NOTICE OF DENIAL

RE: Application Number 23-8201; 761 Whitmore; Palmer Park Apartment Buildings Historic District

CERTIFICATE OF APPROPRIATENESS

Historic District Commission Review
761 Whitmore
Rosemor Apartment Window Replacement

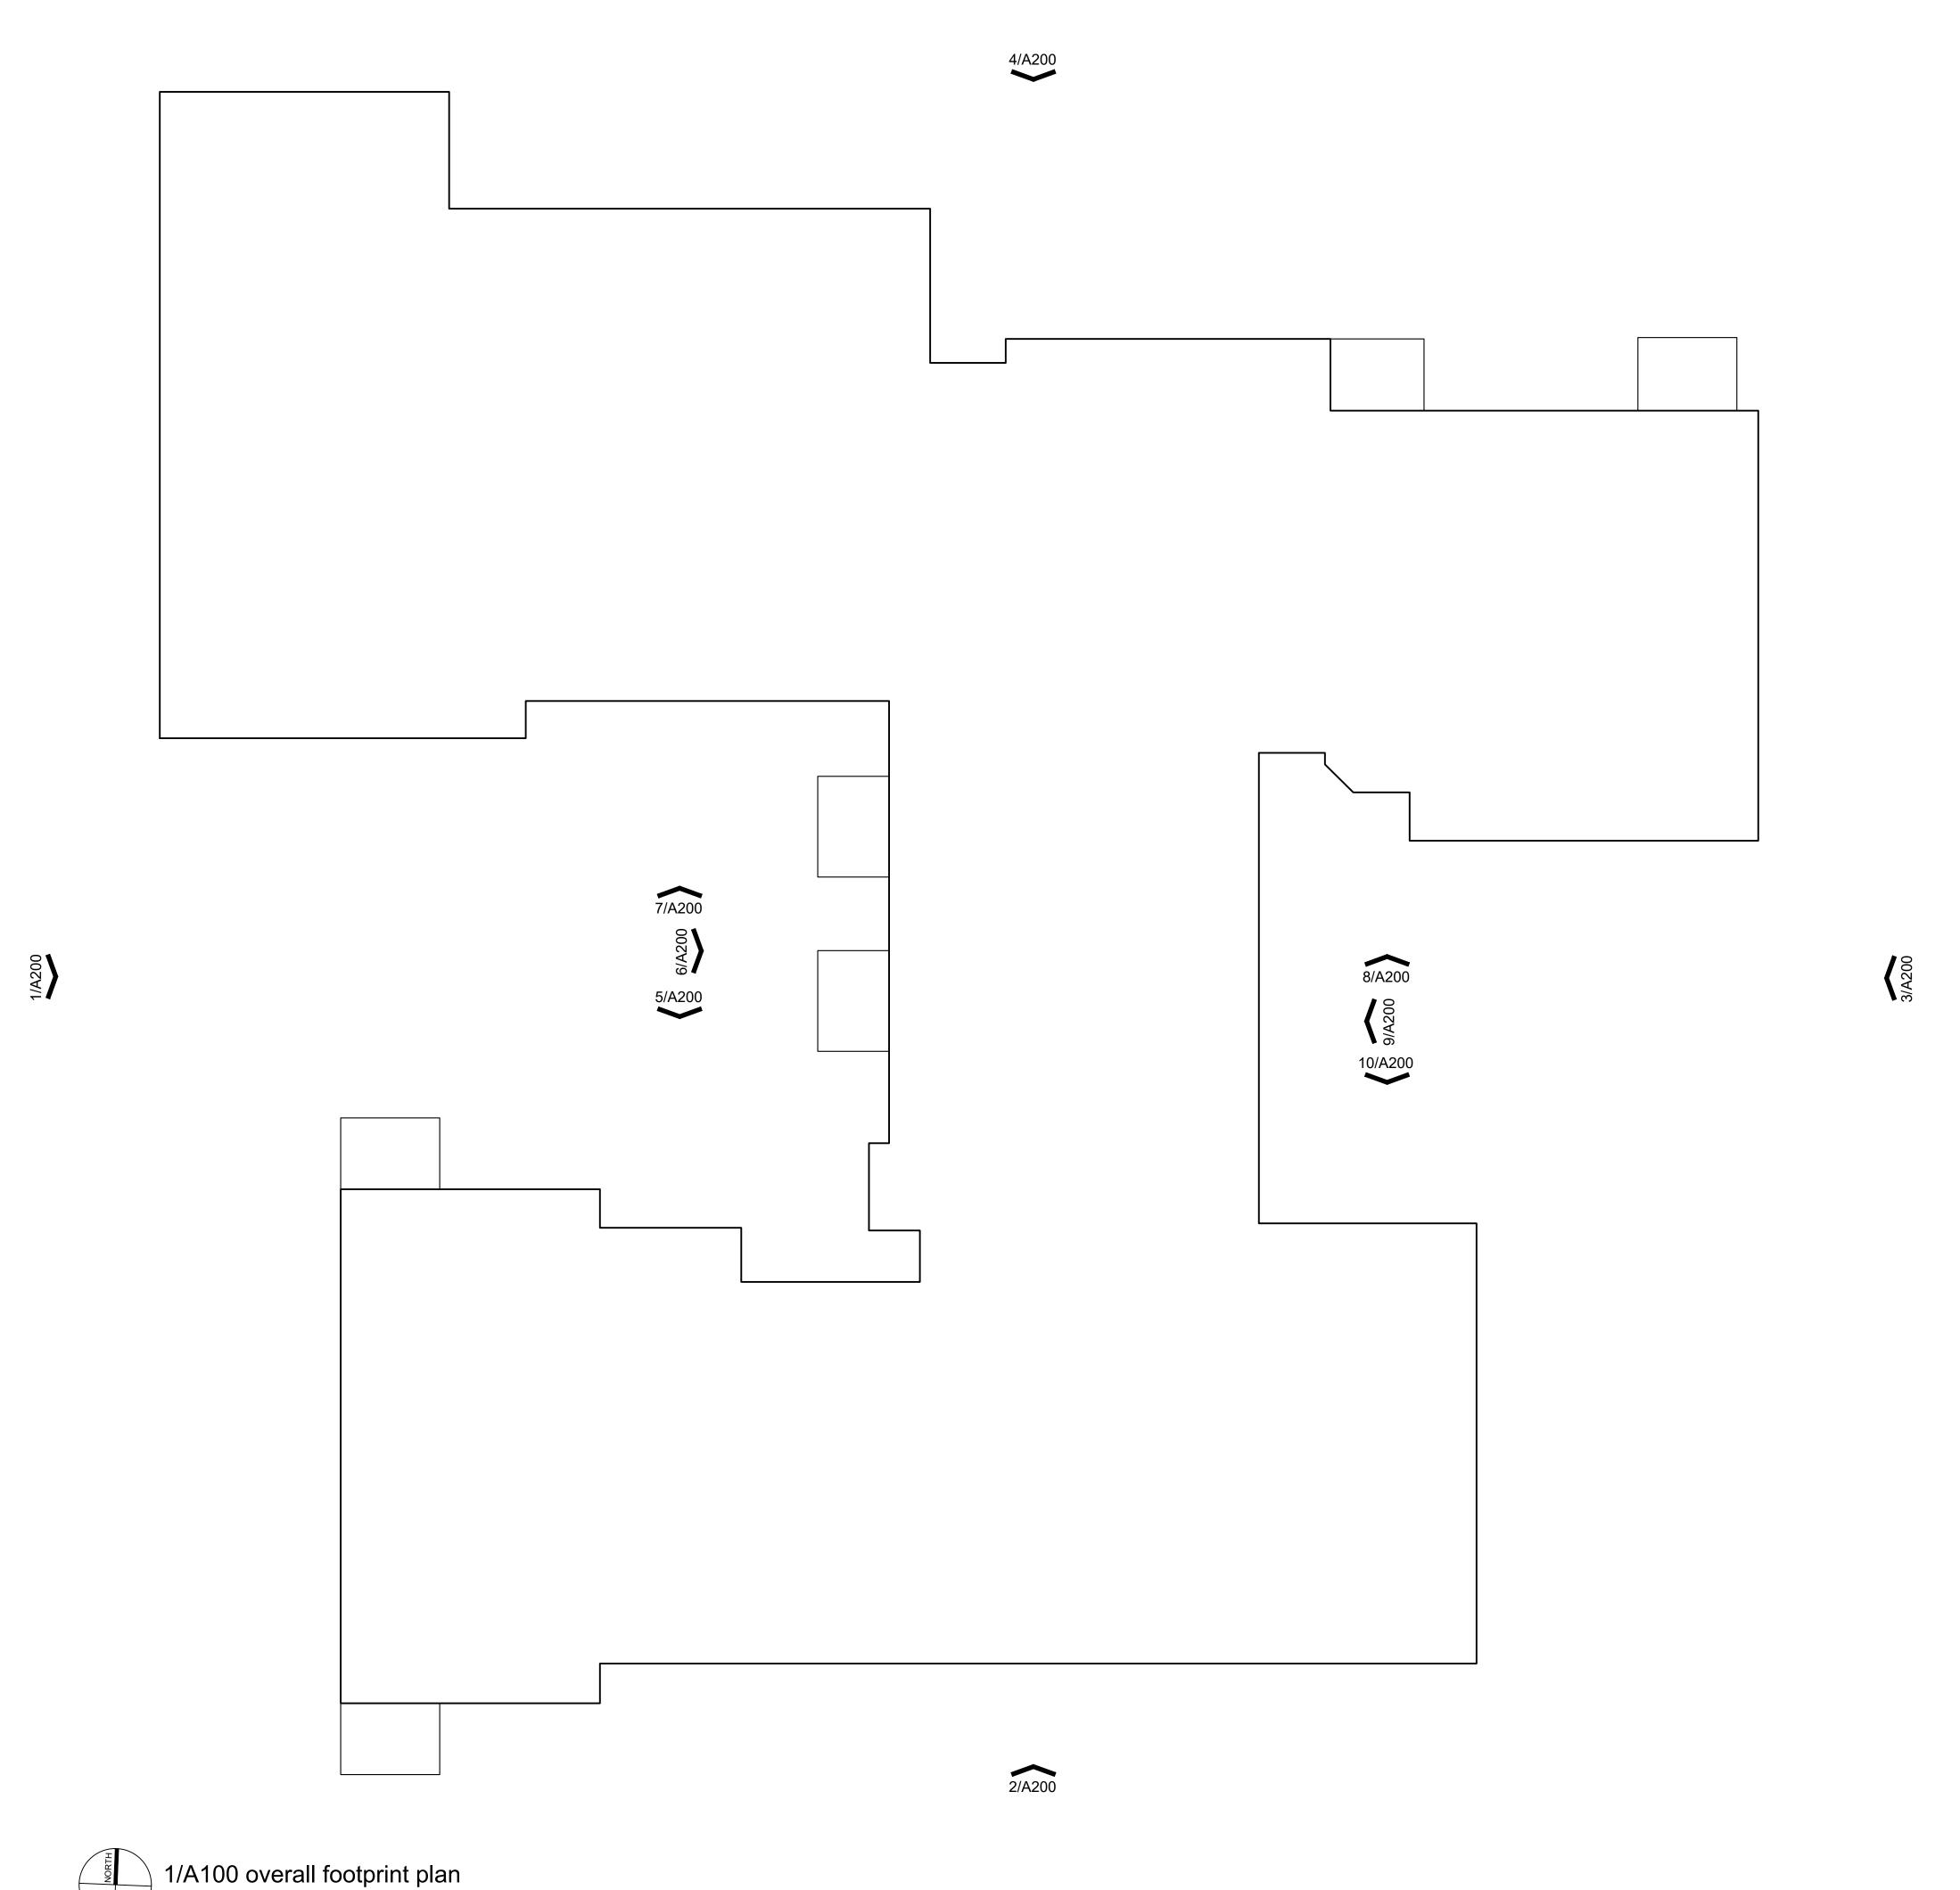
The replacement of the original wood windows and wood brick moulds with vinyl windows and aluminum brick moulds

The Commission's reason for denial is that the proposed work will destroy architectural features that characterize the property.

- The windows that were removed without approval were a distinct historic feature that characterized the property.
- Vinyl material is not an appropriate material for the Palmer Park Apartment Buildings Historic District or this
 particular property.
- The introduction of between the glass muntins, which replaced the true divided light of the original wood windows, is not an adequate match for the original true divided lite of the original windows.
- The current large aluminum brick moulds create a blocky appearance that destroys the refined dimensions and craftmanship of the original wood brick moulds.

3. The original brick moulds were removed. New aluminum brick moulds were installed. The photo above shows the installation of the aluminum brick mould. Unfortunately, I do not have photos of the windows before they were removed. I was not involved with the project at the time of this work.

- 6. The brick on-site is left over from the stabilization work that was completed, inspected and approved. This work was completed under COA 19-6423 and BLD2019-06541.
- 7. My apologies. The windows are constructed of a vinyl composite material.

1/A700 door elevations

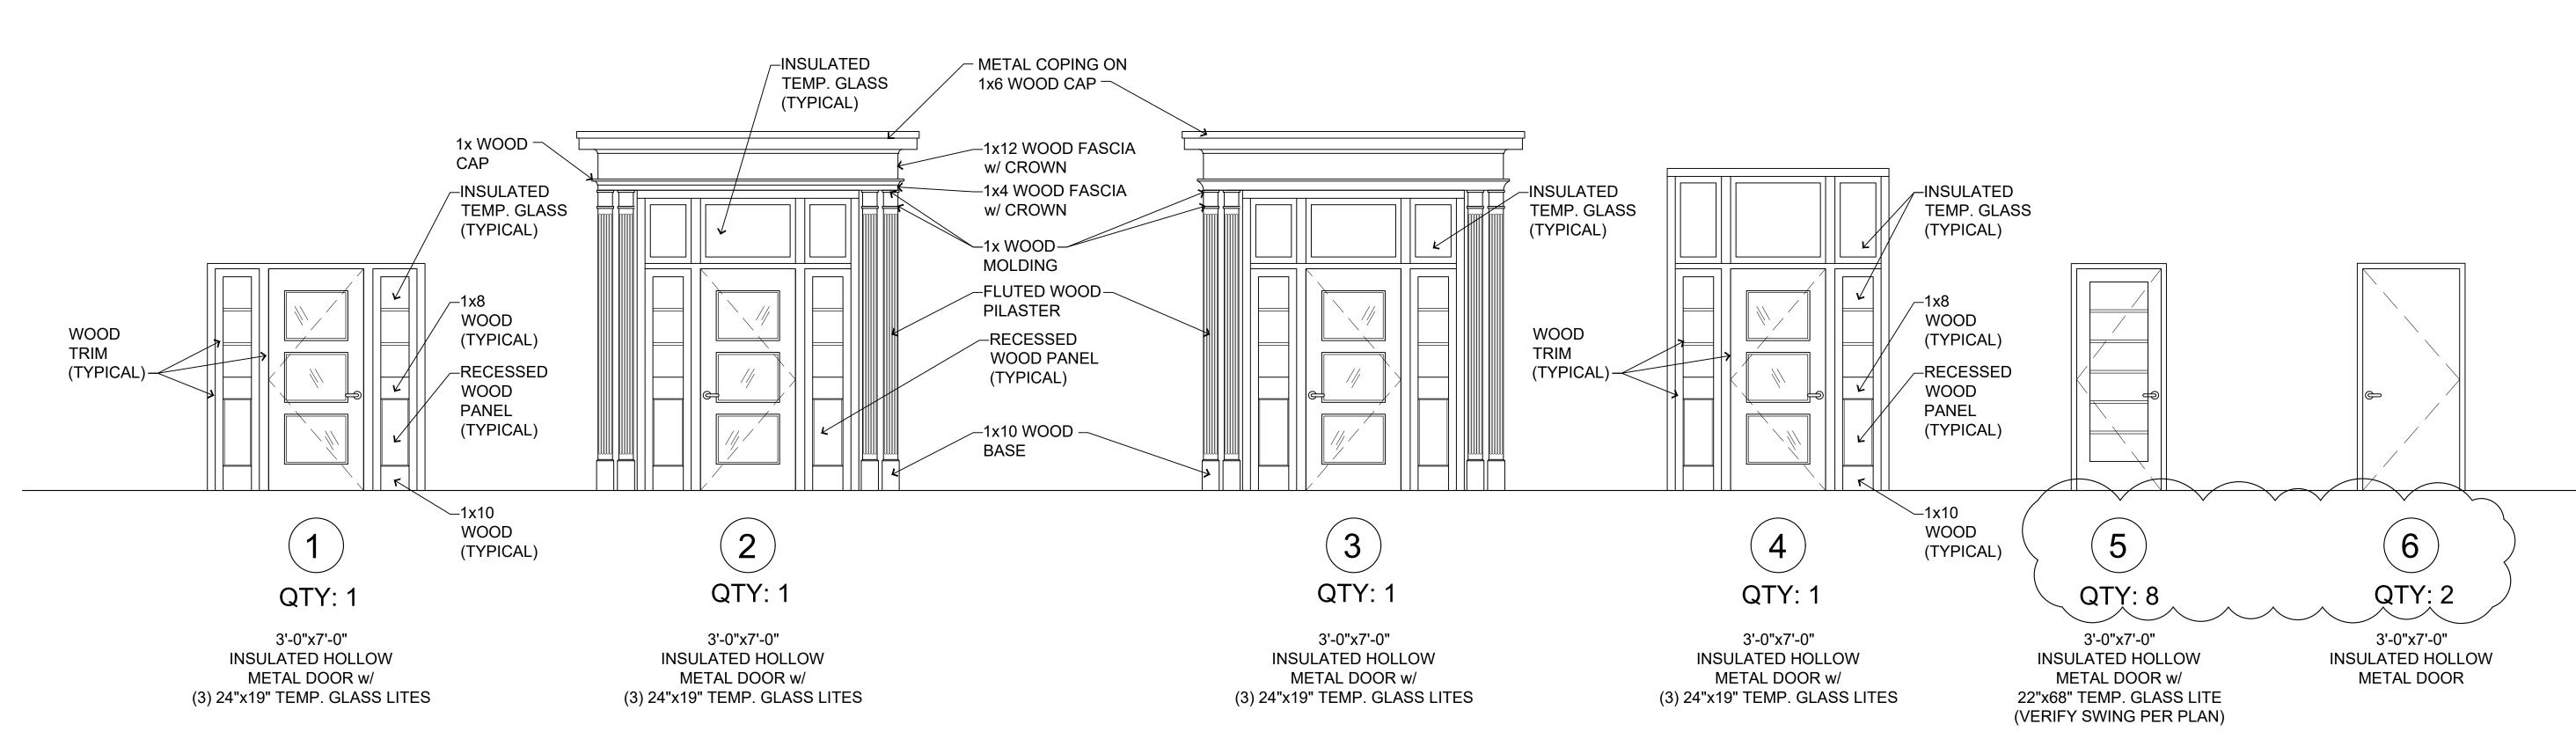
• The installation of the proposed 14 doors and 4 doorways per the attached drawings and details, painted Sherwin Williams (SW7593) Rustic Red

Applicant supplies HDC staff with modified design for the four front entrance doors' window configurations for approval and before installation.
